Addendum 2
Solicitation 24-99842
Upper Lakeside Water Interconnect – Phase 1

ADDENDUM #2

Project Description City of Duluth
Upper Lakeside Zone Water Main Interconnect – Phase 1

V:\Projects\24-525 - Northland Country Club\Design Engineering\DWG_Site Restoration.dwg Nov 27, 2024 - 9:09am dhoite

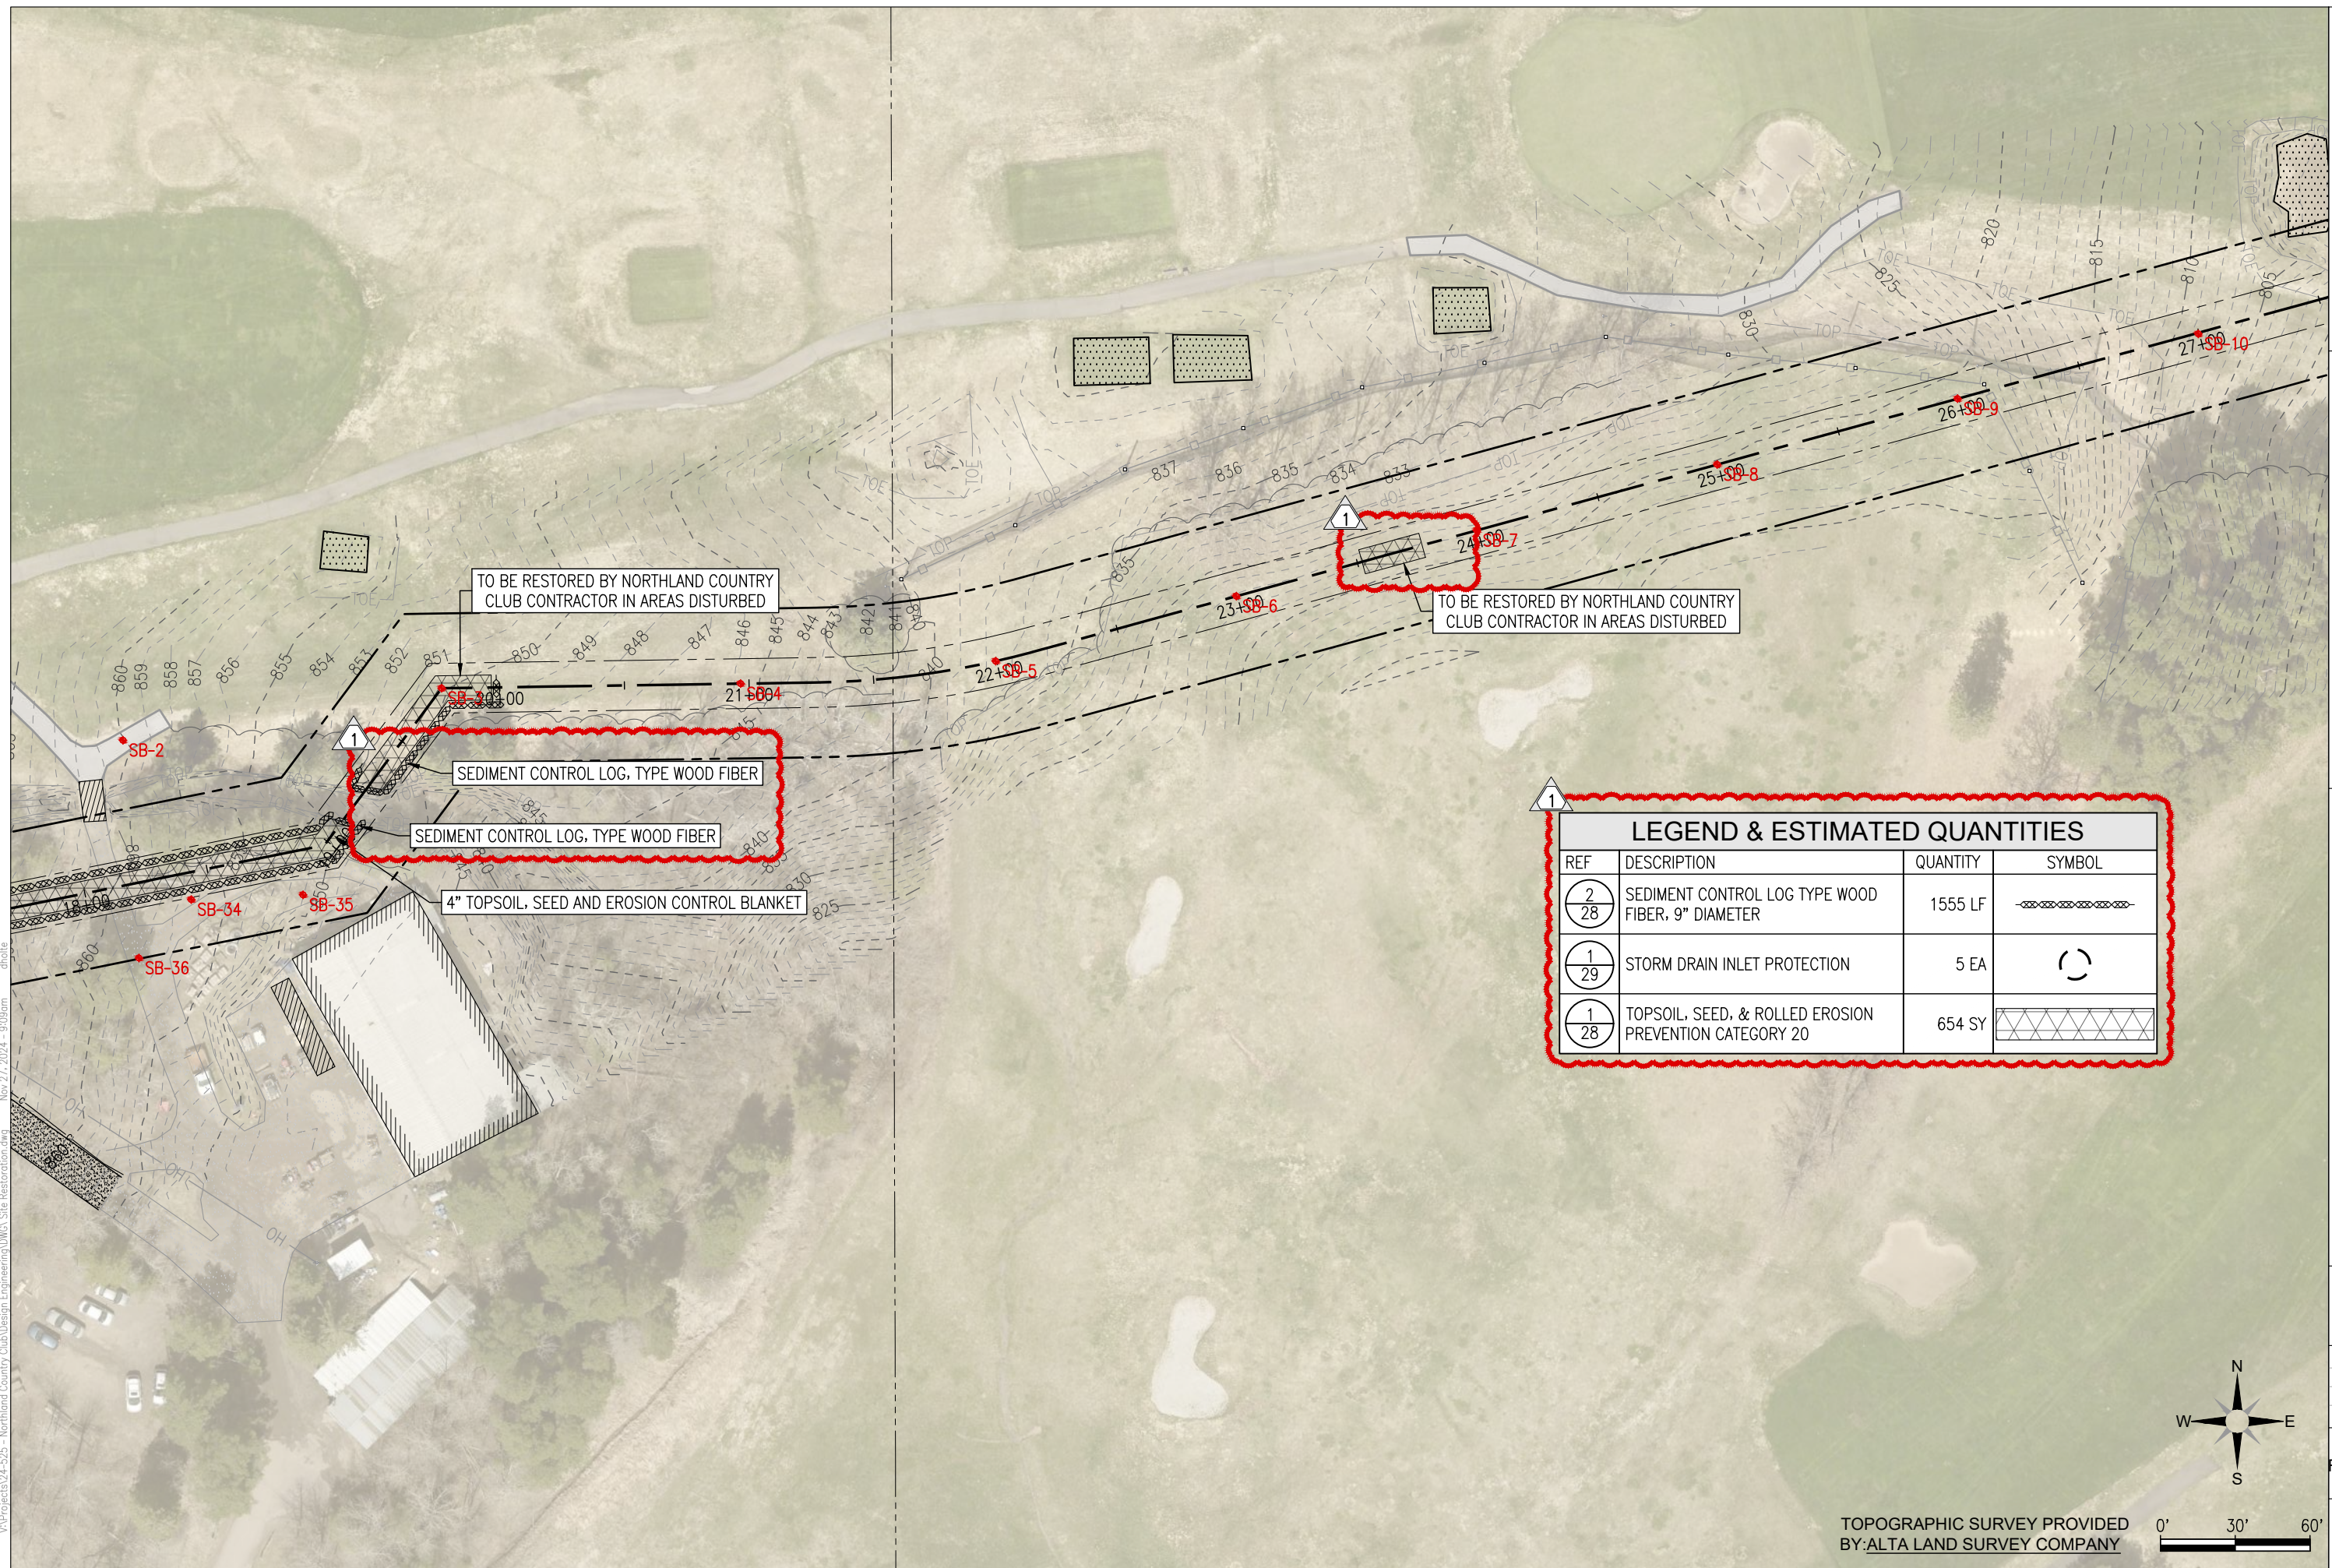
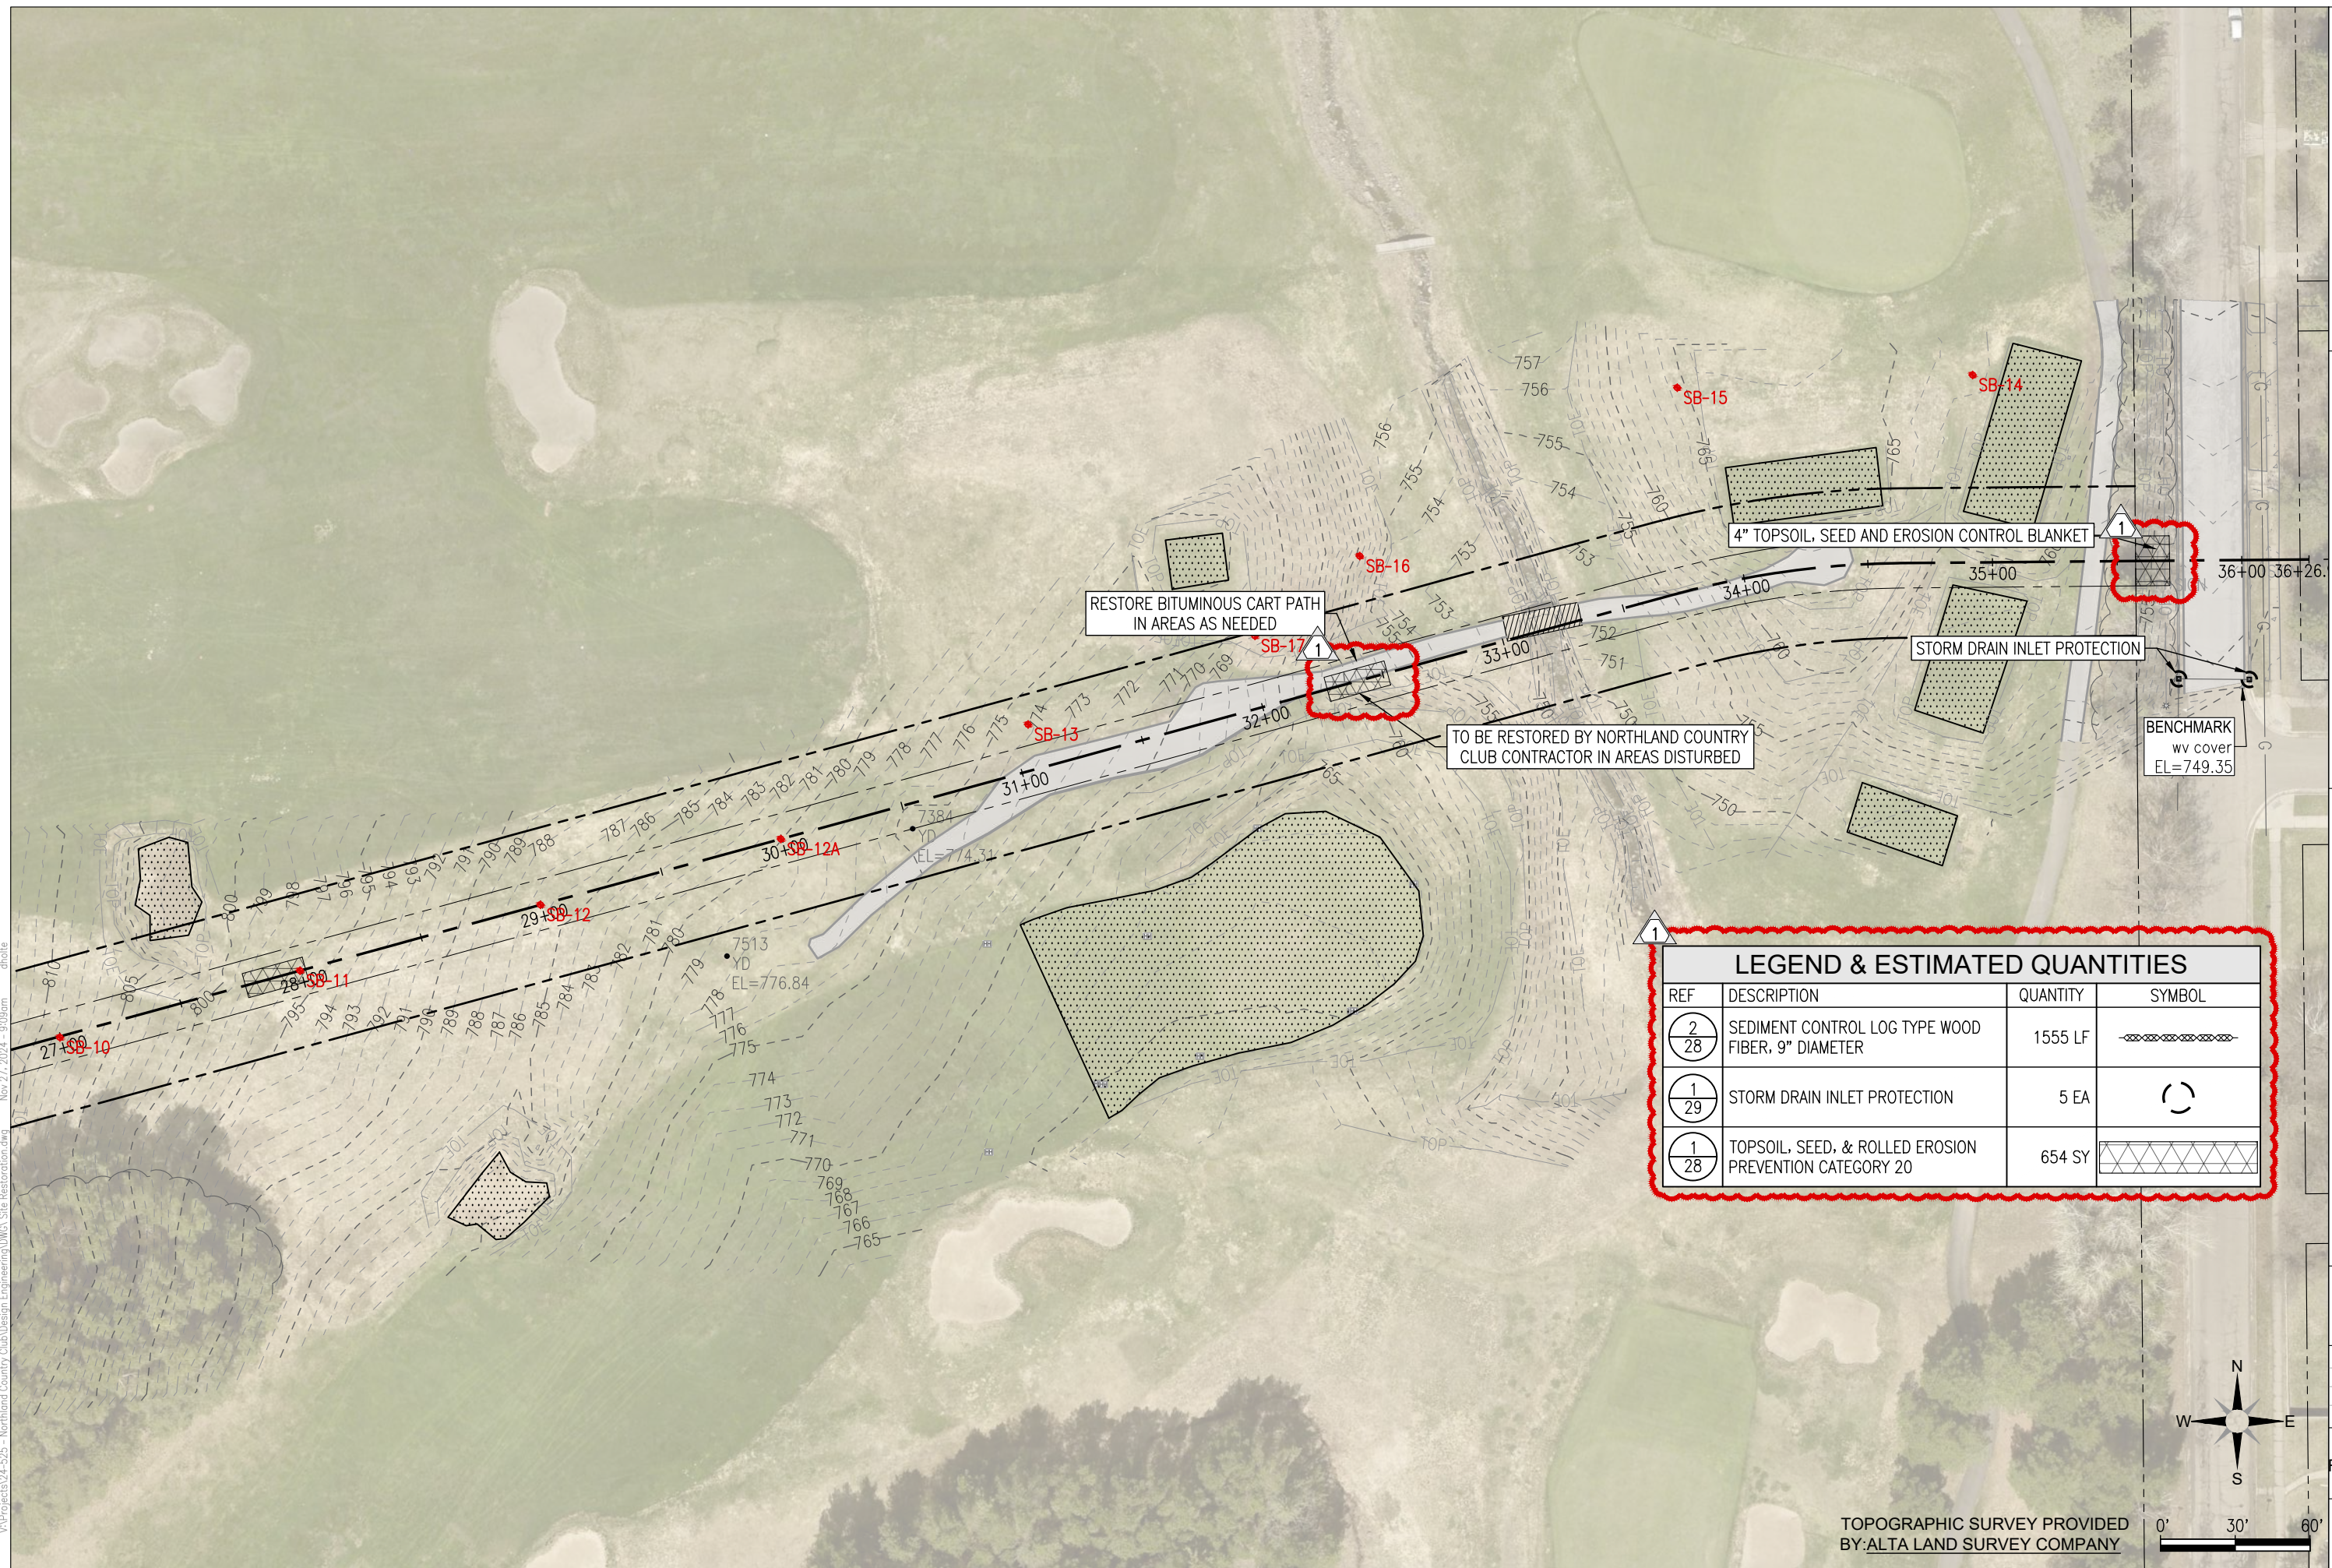
8. Sheets 23-26 SITE RESTORATION:
 - a. Segments of silt fence have been removed at boring pit locations as it won't be necessary.
 - b. Other project silt fence has been switched to sediment control log type wood fiber (9" diameter).

2
28 TEMPORARY SEDIMENT CONTROL
SEDIMENT CONTROL LOGS NTS.

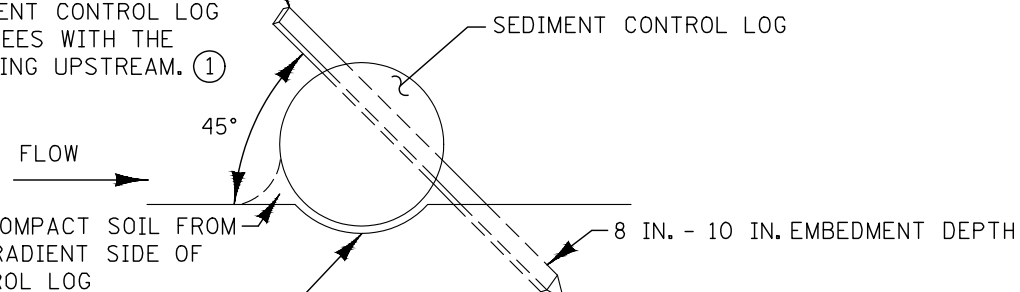
9. Sheet 28 SWPPP DETAILS: Silt fence detail replaced with sediment control log detail.
